Access Compliance Report

Public Rights-of-Way

(Curb Ramps)

Intersection ID: 47969	Main Street: HAWK_SHADOW_LN	Cross Street: TURNING_HAWK_RD	Location: NW
ADA ID: 41260F2730CE	Ramp Type: Perp	Initial Pass/Fail: Fail	Overall Compliance: No
Severity Score: 8.75			
Codes/Mitigation Info/Possible Solution		Field Measurements/Component Compliance

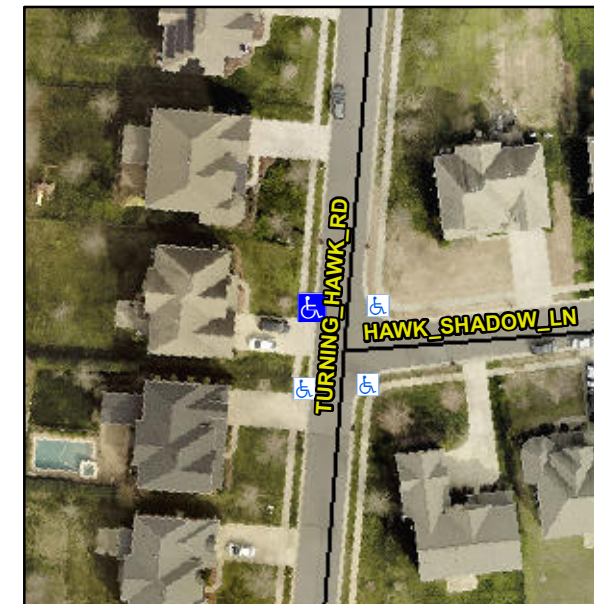
Not Found, R304.5.1

Compliance	Description	Data	Compliance	Description	Data
N/A	Ramp Length (in)	47.0	Yes	Ramp Slope (%)	7.3
No	Ramp Width (in)	47.0	Yes	Ramp XSlope (%)	1.9
N/A	Flare Type LT	N/A	N/A	Flare Type RT	N/A
N/A	Flare Slope LT (%)	N/A	N/A	Flare Slope RT (%)	N/A
N/A	Flare Traversable LT?	N/A	N/A	Flare Traversable RT?	N/A
N/A	Landing Length (in)	N/A	N/A	DWS Provided?	N/A
N/A	Landing Width (in)	N/A	N/A	DWS Contrast?	N/A
N/A	Landing Slope (%)	N/A	N/A	DWS Length (in)	N/A
N/A	Landing X Slope (%)	N/A	N/A	DWS Full Width?	N/A
N/A	Landing Curb? (Y/N)	N/A	N/A	DWS Offset (in)	N/A
N/A	Shared Landing?	N/A			
N/A	Gutter Ponding?	N/A	N/A	Gutter Slope (%)	N/A
N/A	Gutter Lip Ht (in)	N/A	N/A	Gutter X Slope (%)	N/A
N/A	Painted X Walk1?	No	N/A	Painted X Walk2?	N/A
	X Walk 1 Direction	To SE		X Walk 2 Direction	N/A
N/A	X Walk 1 Width (in)	N/A	N/A	X Walk 2 Width (in)	N/A
	X Walk 1 Slope (%)	3.0		X Walk 2 Slope (%)	N/A
	X Walk 1 X Slope (%)	1.5		X Walk 2 X Slope (%)	N/A

Remove & Replace Entire Ramp.
